**Table of Assessment – Planning Proposal – 95-97 Stanhope Road, Killara**

## PLANNING PROPOSAL - ATTACHMENT A - URBAN DESIGN REPORT

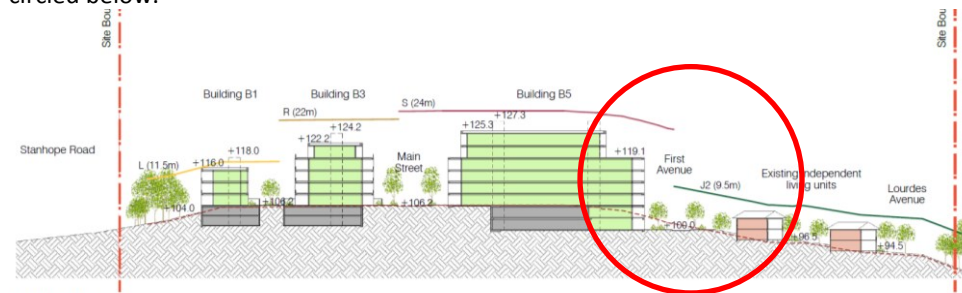
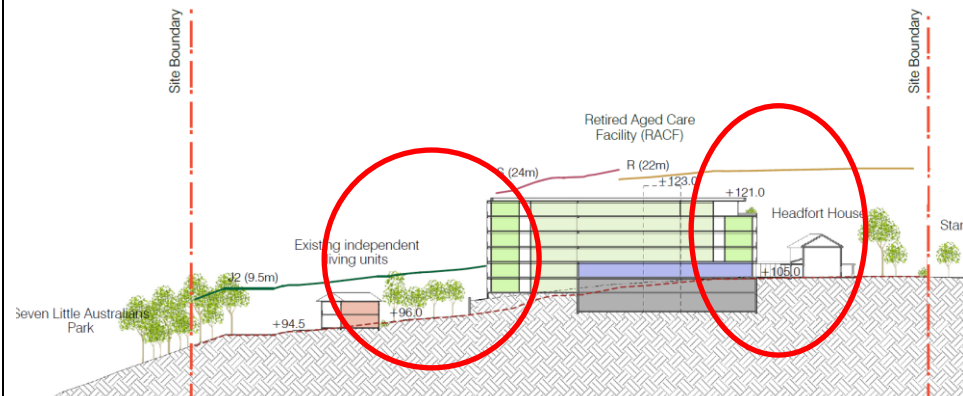
The sections also show that there is a possibility to include additional levels within the height plane as indicated by red circle below. Whilst FSR will limit the amount of development, building heights are a key consideration at this location. Any future proposal would have the ability to compose smaller footprint within

FSR limits to achieve these additional levels.

**Section E**

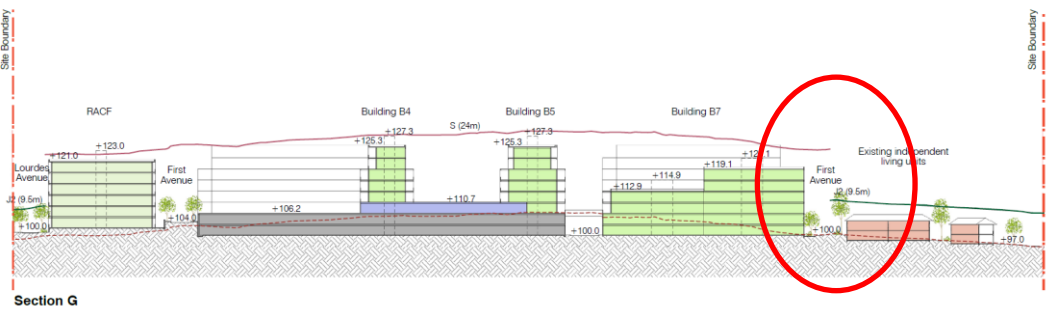
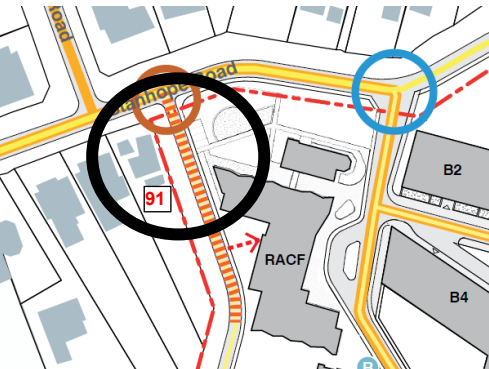
A key issue regarding the outcomes depicted in this urban Design Study is the lack of interface consideration with low density residential development on the site itself, on the neighbouring site at 91 Stanhope, and to Headfort House which has been found worthy of local listing. Some of the bulk, massing, scale issues are circled below.

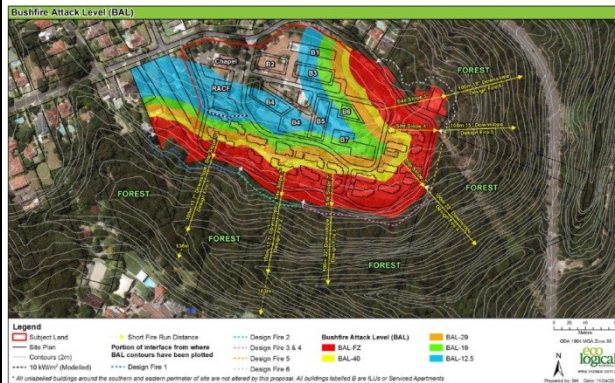
PAGE	DOCUMENT/SECTION	COMMENT
1-2	Sections 1.1 & 1.2 of the report details the description of the proposal, location and description of the development site and includes a comment that the <i>"locality has not had a widespread wildfire and is never likely to experience this as the vegetation is confined to relatively narrow pathways in</i>	<p>Figure 1 below (taken from the Independent Review of Bushfire Impact, Australian Bushfire Protection Planners Pty), provides a graphical representation of the fire paths which are likely to present a hazard to the site and identifies that there is a 1.2 kilometre fire path from the northeast with a potential head width of more than 300 metres.</p>

<p><i>directions that are not exposed to widespread and major bushfires”.</i></p>	<p>The fire path from the southeast has a length of more than 450 metres with a potential head width of more than 250 metres.</p> <p>Figure 1 – Plan of Potential Fire Paths</p>  <p>The likelihood of bushfire as described within the Bushfire Protection Assessment, should either clarify their proposed fire paths or address those raised within the comments section which clearly show significant fire paths (particularly to the northeast).</p>
5-6	<p>Section 2 of the report undertakes a Bushfire Threat Assessment which includes the determination of the ‘predominant vegetation class’ for a distance of at least 140 metres out from the site and the slope class ‘most significantly affecting fire behaviour’ for a distance of at least 100 metres in all directions.</p>	<p>The report correctly classifies the ‘predominant vegetation’ to the north-east through to the south to southwest of the development as ‘forest’.</p>

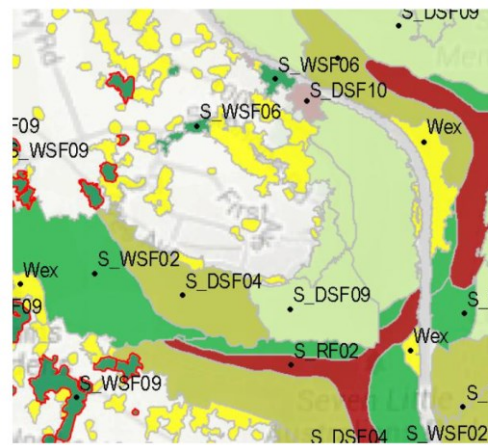
13	<p>Section 4.1</p> <p><i>"There are no extensive naturally occurring or reconstructed ecological communities occurring on site (Figure 3). A small patch of woodland including two individuals of Turpentine and one of Sweet Pittosporum occurring at the western section of the subject land (Figure 4) may be derived from genotypic material from a former distribution of Sydney Turpentine Ironbark Forest that would have been aligned with the edges of the Wianamatta Shale/Hawkesbury Sandstone stratification boundaries (Figure 3.)"</i></p>	<p>Council supports the position that the site supports Sydney Turpentine Ironbark Forest under the <i>NSW Biodiversity Conservation Act 2016</i>.</p> <p>Analysis of Aerial photograph within the site from 1943 to 2016 (see appendix 1 below), shows persistent vegetation within areas mapped by the NSW Office of Environment and Heritage as Sydney Turpentine Ironbark Forest (as shown within Figure 3 of the Ecological Assessment).</p> <p>The vegetation assemblage, landscape and soils within these areas are consistent with the scientific listing of Sydney Turpentine Ironbark Forest under the <i>NSW Biodiversity Conservation Act 2016</i>. It is also consistent in that the determination recognises this community even within areas where the original forest or woodland structure no longer exist (i.e. individual remnant trees).</p> <p>This is clearly supported within point 2,3, 8 and 9 of the <i>Sydney Turpentine-Ironbark Forest - Determination to make a minor amendment to Part 3 of Schedule 1 of the Threatened Species Conservation Act</i>, which states:</p> <p><i>"2. The total species list of the community is considerably larger than that given in 1 (above), with many species present in only one or two sites or in very small quantity. In any particular site not all of the assemblage listed in 1 may be present. At any one time, seeds of some species may only be present in the soil seed bank with no above-ground individuals present. The species composition of the site will be influenced by the size of the site and by its recent disturbance history. The number of species and the above-ground composition of species will change with time since fire, and may also change in response to changes in fire frequency.</i></p> <p><i>3. The structure of the community was originally forest, but may now exist as woodland or as remnant trees."</i></p> <p><i>8. STIF typically occurs on areas with clay soils derived from Wianamatta Shale, or shale layers within Hawkesbury Sandstone.</i></p>
